AS-BUILT CREW PRINT		<small>ALL REQUIRED GROUND RODS HAVE BEEN DRIVEN & VERIFIED TO BE WITHIN FPL STANDARDS. VALUES ARE SHOWN AT ALL LOCATIONS.</small>		<small>JOB CERTIFIED COMPLETED AS SHOWN ON THIS AS-BUILT PRINT. MATERIAL CHANGES SHOWN IN RED.</small>		AS-BUILT COPY	
FOREMAN'S SIGNATURE _____ DATE _____		FOREMAN'S SIGNATURE _____ DATE _____		SUPERVISOR'S SIGNATURE _____ DATE _____		INITIALS _____ CERT. DATE _____	
Easement?	Yes <input type="checkbox"/> No <input checked="" type="checkbox"/>	Survey/Stake?	Yes <input type="checkbox"/> No <input checked="" type="checkbox"/>	Work with SMO?	Yes <input type="checkbox"/> No <input checked="" type="checkbox"/>	FPL FDOT – City of Pahokee Install 50 New Lights v/o SR 15/US 441 (from S of Shirley Dr to Main St), Pahokee, FL 33476	
Tree Work?	Yes <input type="checkbox"/> No <input checked="" type="checkbox"/>	Designer/Stake?	Yes <input type="checkbox"/> No <input checked="" type="checkbox"/>	CT/Special Mtr?	Yes <input type="checkbox"/> No <input checked="" type="checkbox"/>

FDOT - City of Pahokee
 Install 50 New Lights
 v/o SR 15/US 441 (from S of Shirley Dr to Main St), Pahokee, FL 33476
 Designed by: Jessica Builes Date: 02/20/23
 Drawn

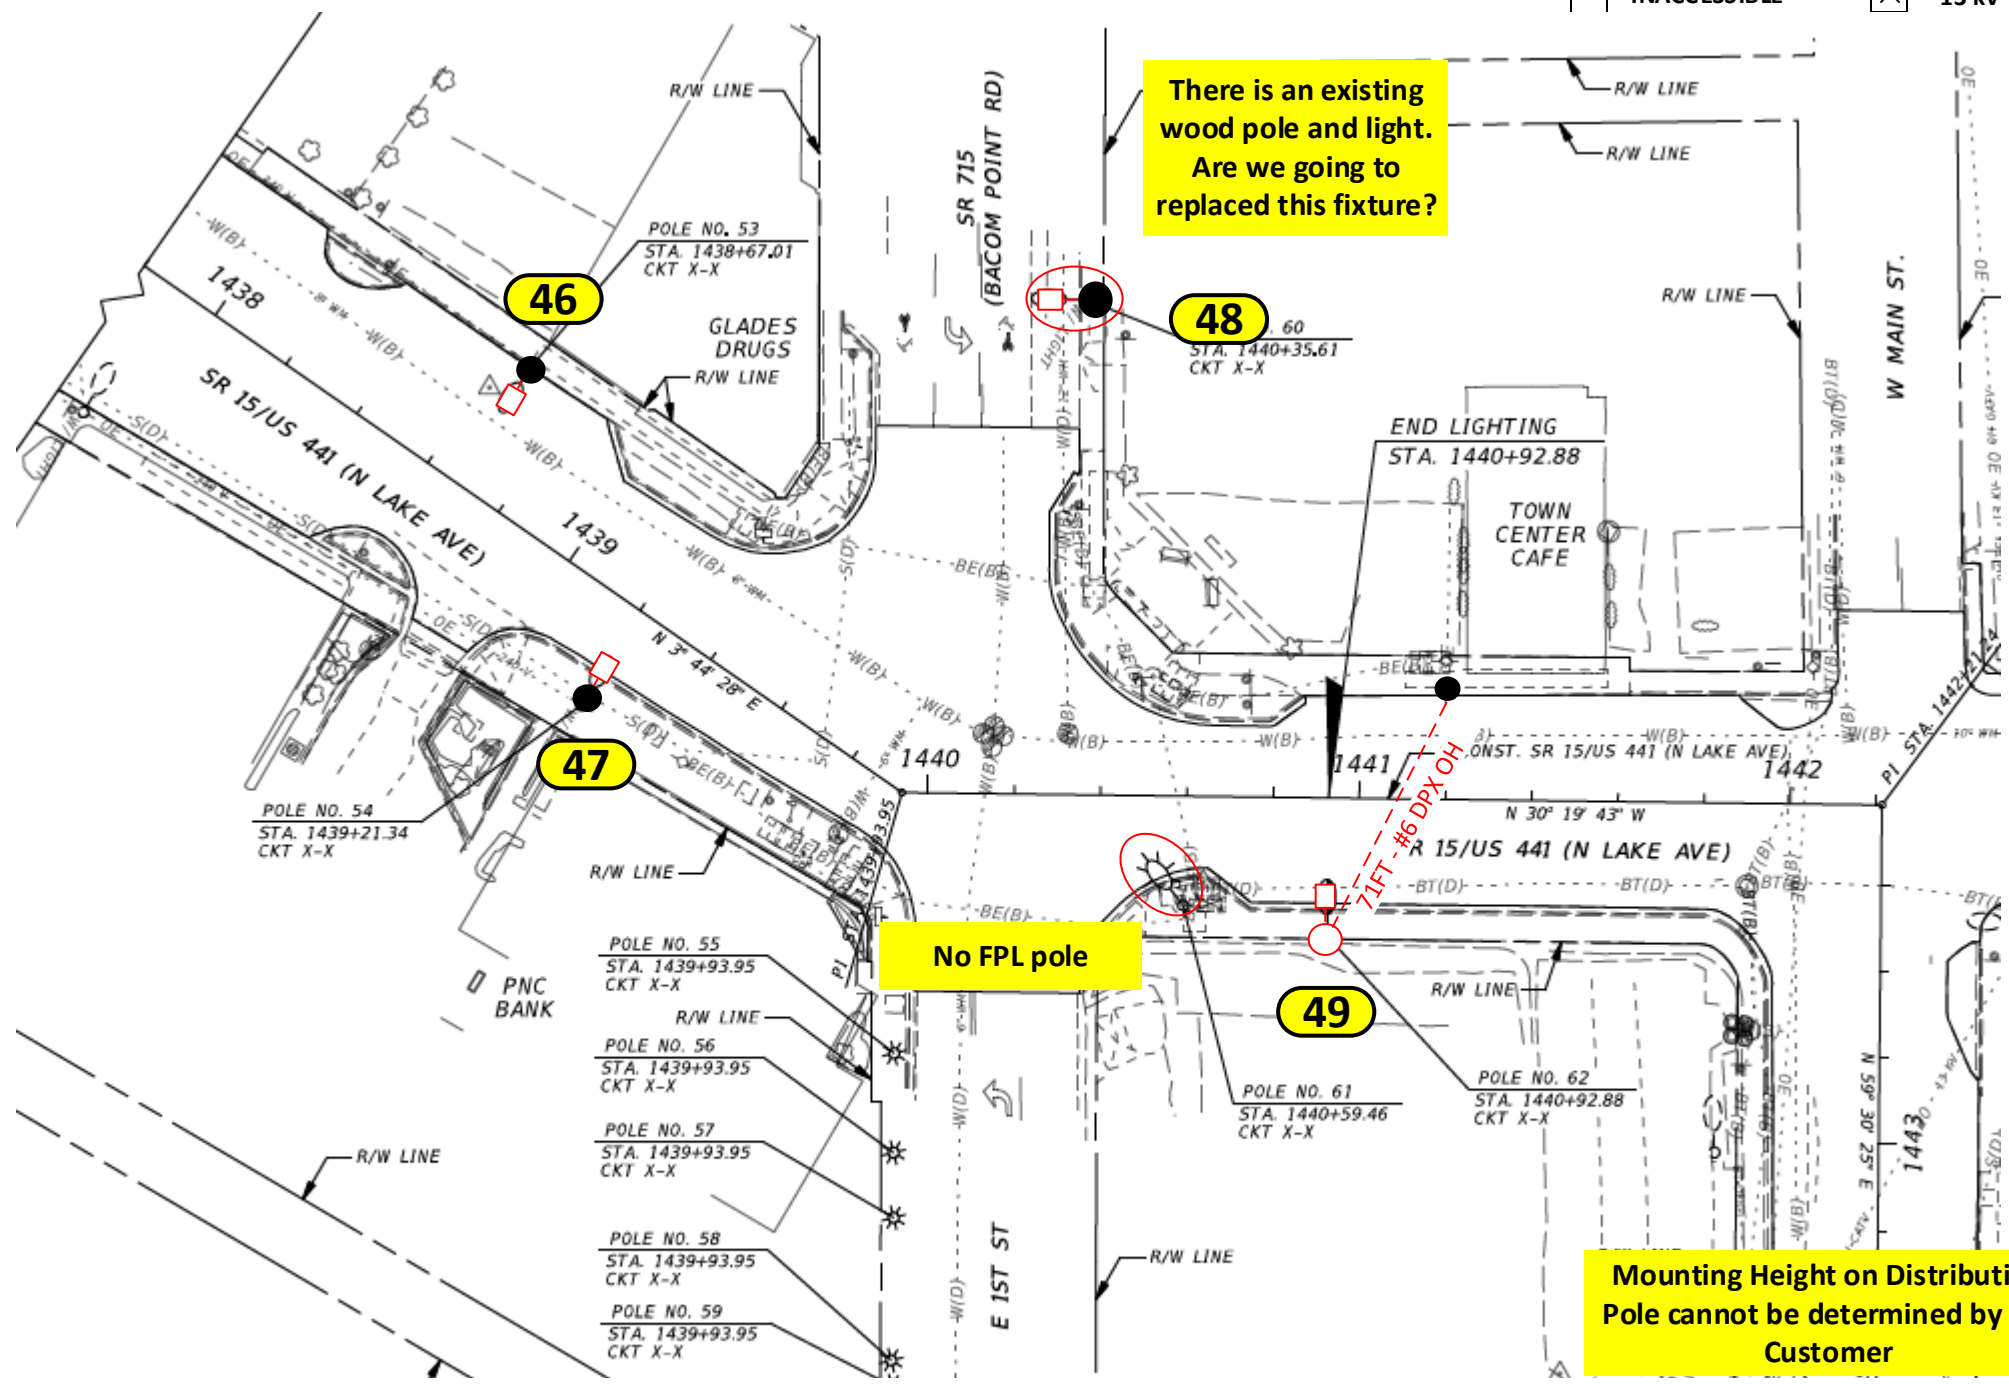
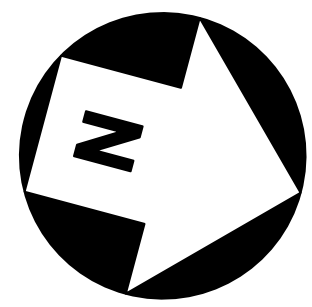
There is an existing wood pole and light. Are we going to replaced this fixture?

Mounting Height on Distribution Pole cannot be determined by the Customer

No FPL pole
